## STAFF REPORT

**FILE NUMBER:** H-24-53

**REQUEST:** Rezoning from CPDP (Combined Planning Development Project) with GC (General Commercial) and SF (Single-family) uses, and CPDP (Combined Planning Development Project) with OP (Office Professional) and Congregate Care Facility uses, to PDP(MF)/ Planned Development Project (Multifamily).

Figure 1: Property Lines of the Northeast portion of the project

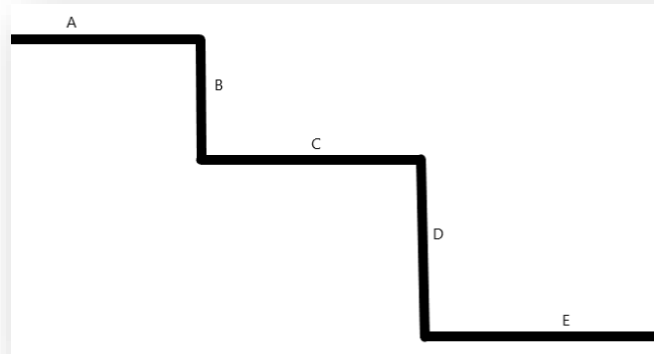
**E. Perimeter Setbacks (including the vegetated buffer) (see figure 1)**

- North (Cortez Boulevard (SR 50)) (A): 75'
- North (C & E): 30'
- South: 45'
- East (Emerson Rd): 35'
- East (B and D): 30'
- West (Oxley Road): 45'

**F. Buffers (see figure 1 for a visual representation of the northeast buffer locations)**

- North (A) (Cortez Boulevard (SR 50)): 45' Landscaped Buffer
- North (C): 30' Landscaped Buffer
- North (E): 5' Landscaped Buffer
- South: 15' Landscaped Buffer
- East (Emerson Rd): 35' Landscaped Buffer
- East (B): 15' Landscaped Buffer
- East (D): 5' Landscaped Buffer

- West (Oxley Road): 20' Landscaped Buffer
